Project Name: Pearl Fire Stations

Project Number: 22-099 & 22-108

ADDENDUM NO. 03

5 Section 5 - S113
3/4" = 1'-0"

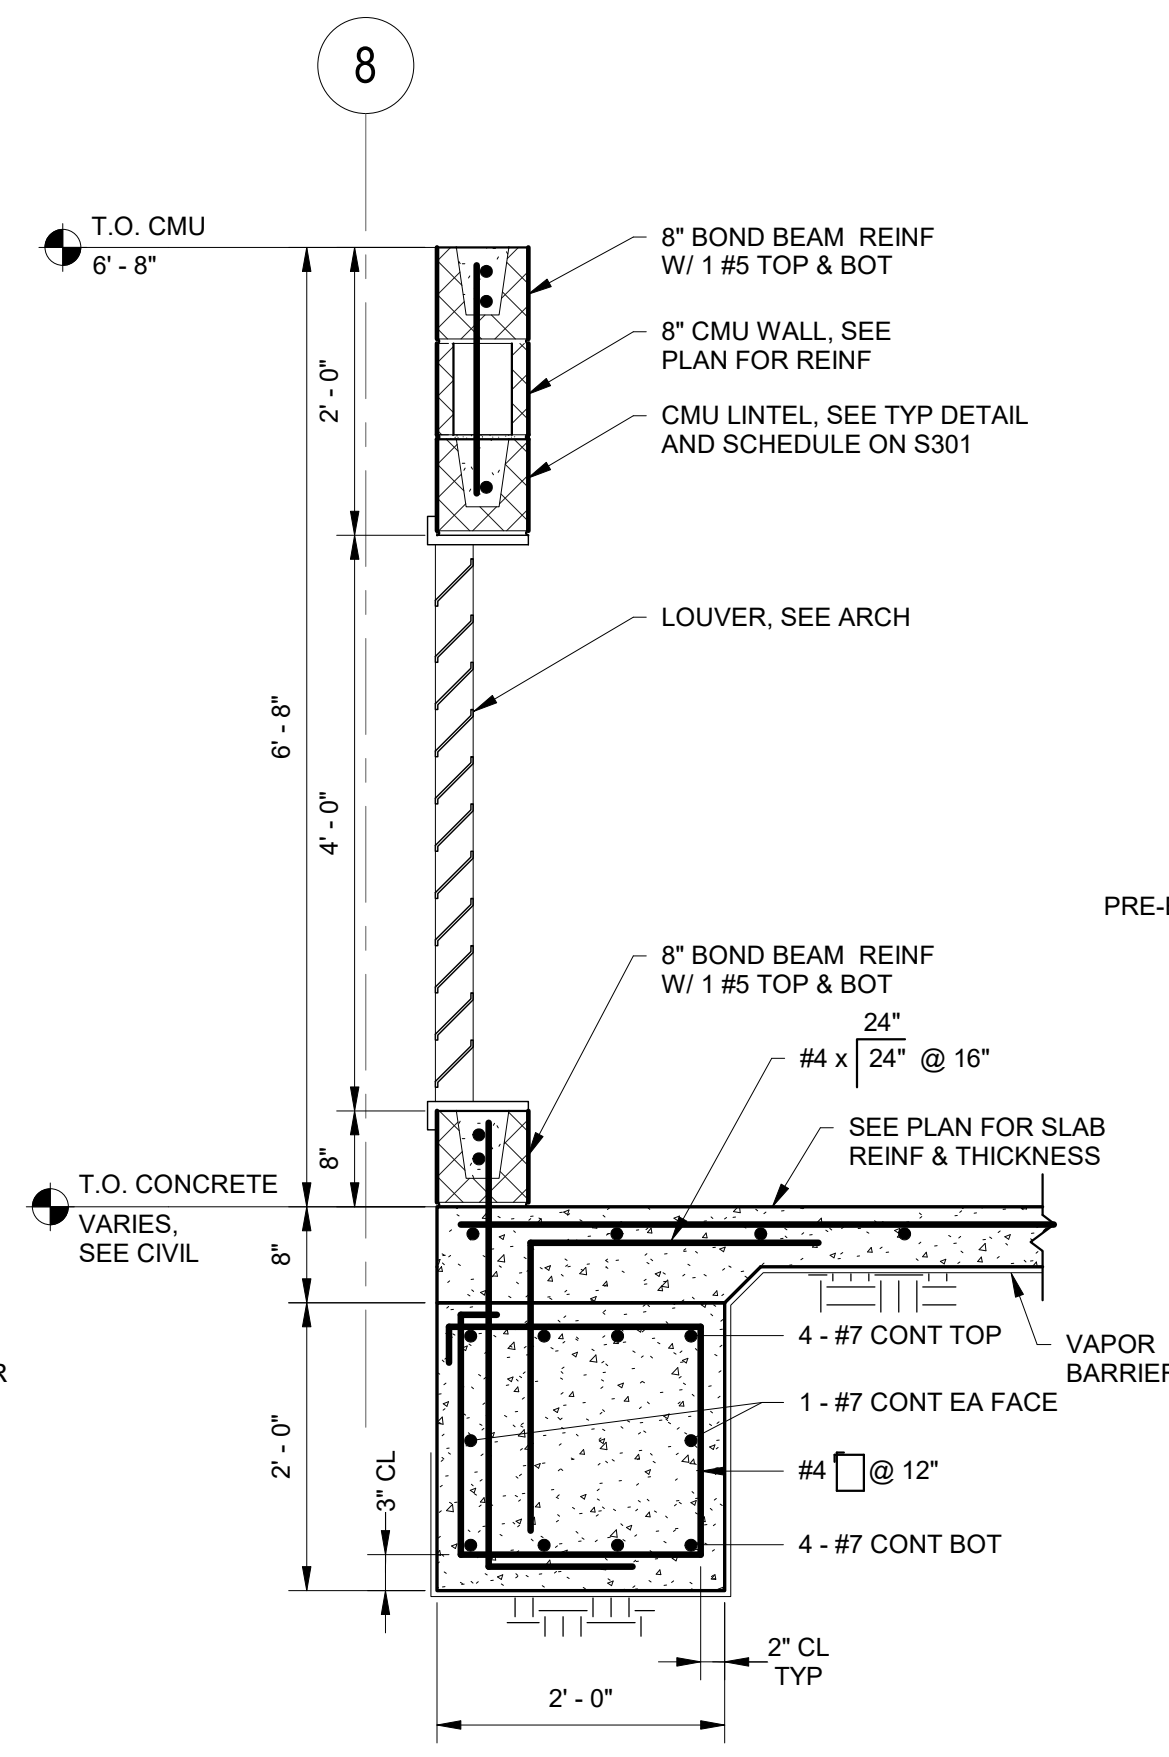
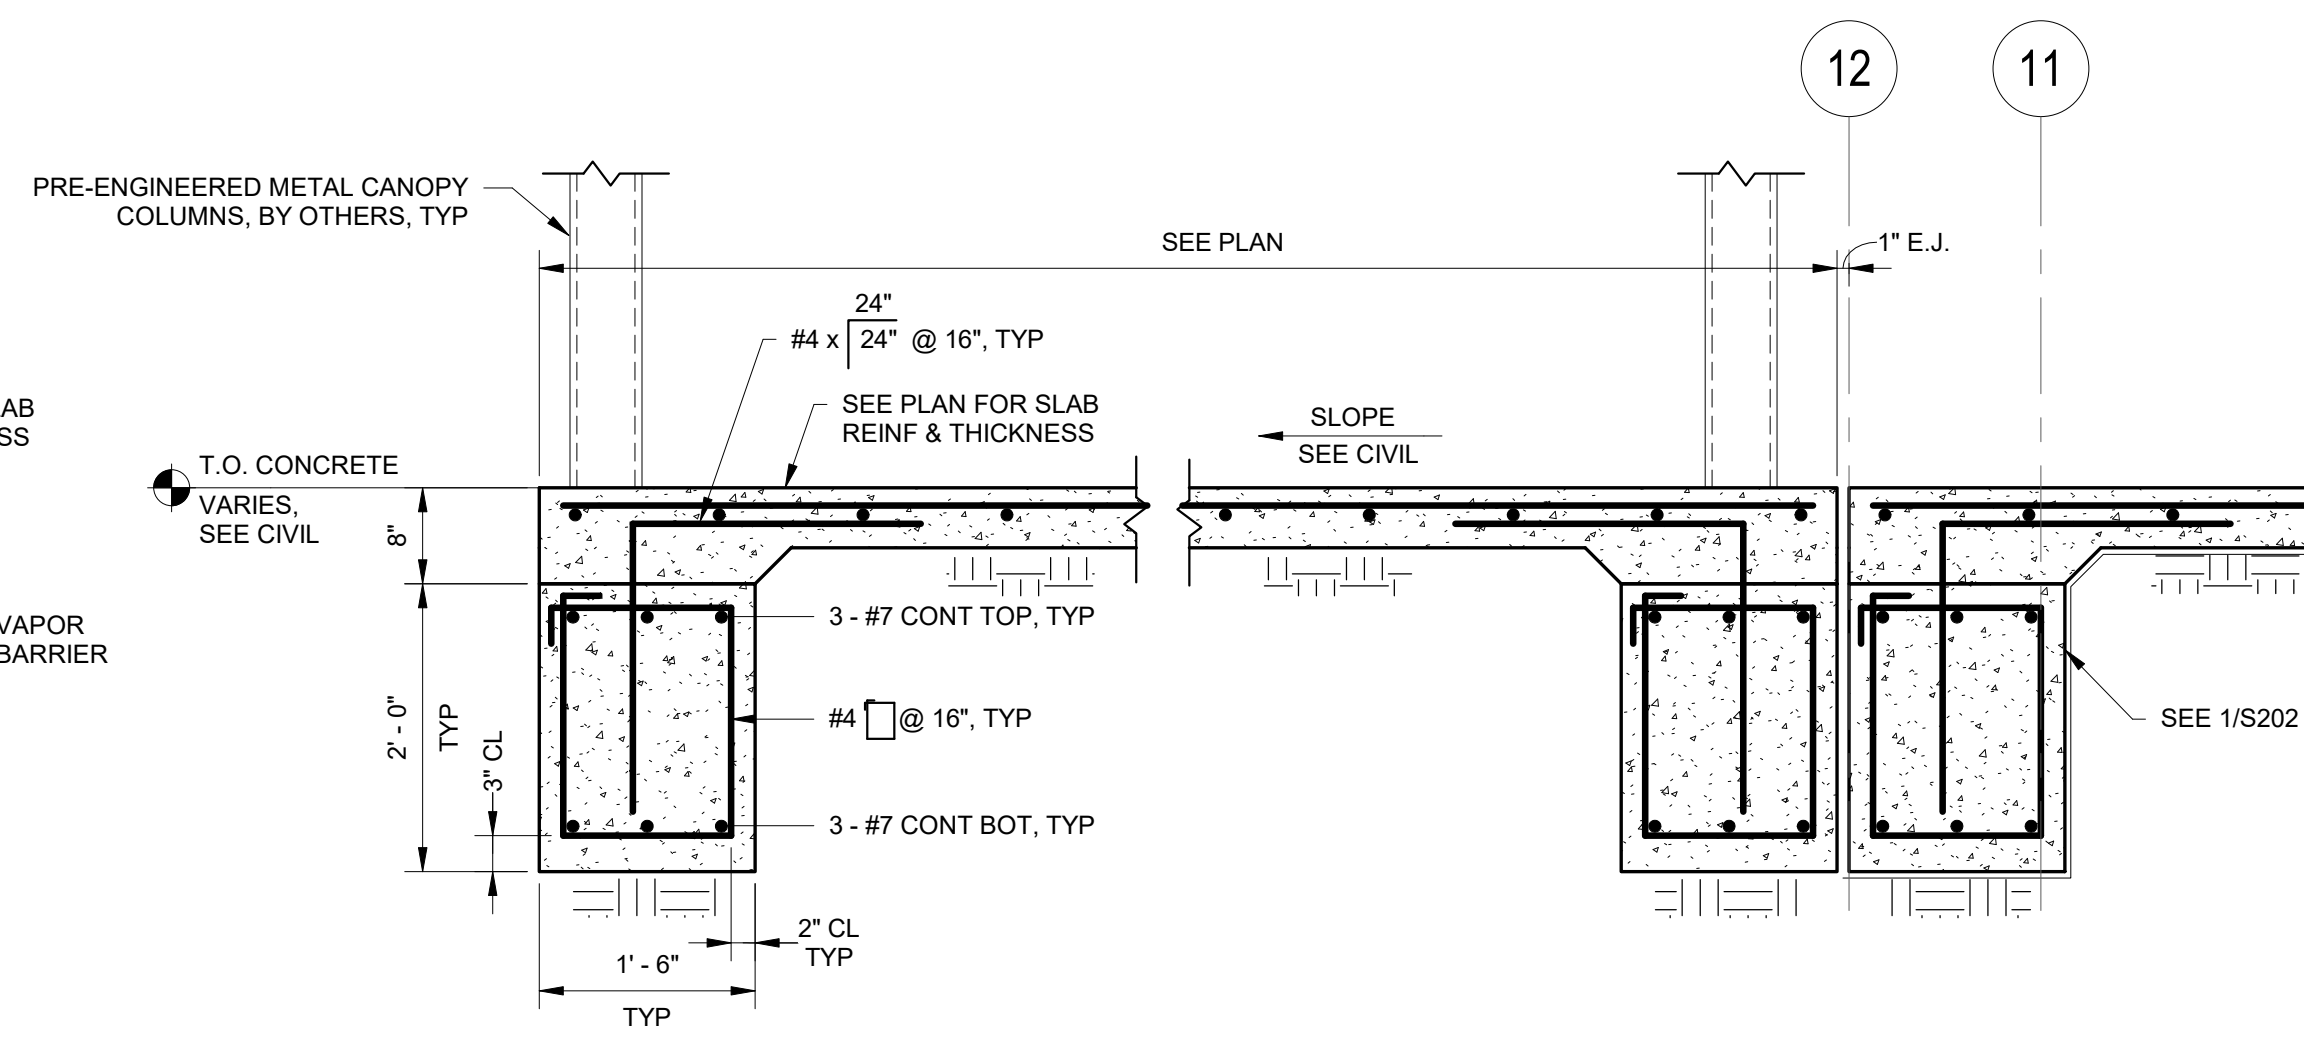
- ITEM NO. 11 **S113 Partial Foundation Plan - Central Station**
ADD Sheet S0113 in its entirety.
Clarification: New sheet S113 provides foundation and slab information for trash enclosure and generator slab at Central Fire Station. Sheet also includes retaining wall information.

8	The site plans show a retaining wall on Sheet C210 and says See Structural and there is nothing in the structural about a retaining wall. Also the Arch and Civil Drawing show Dumpster Enclosures and there is no details for the foundations or the walls. Please provide	23-Aug-23	Cecil Mason, Flagstar Construction	Addendum 2 (issued 9/1/23) included detailed information about the Dumpster Enclosures and Mechanical Yard Enclosures. Addendum 3 includes the requested structural information.
9	The 2 canopies for the alternates you do not show any detail for them either. Is there a slab under them or what???	23-Aug-23	Cecil Mason, Flagstar Construction	Post-supported canopies are specified via Section 10.7315, updated via Addendum 3. Slab details are included in Addendum 3 structural updates.
10	Spec section 26.43.00-1.1.A Calls for a Surge Protective Device, but this is not shown on the drawings. Please advise if this is needed and where to locate them for each station.	7-Sep-23	Alvin Willey, Thrash Commercial Contractors, Inc.	Provide a Type 2A SPD in the main panel of each building.
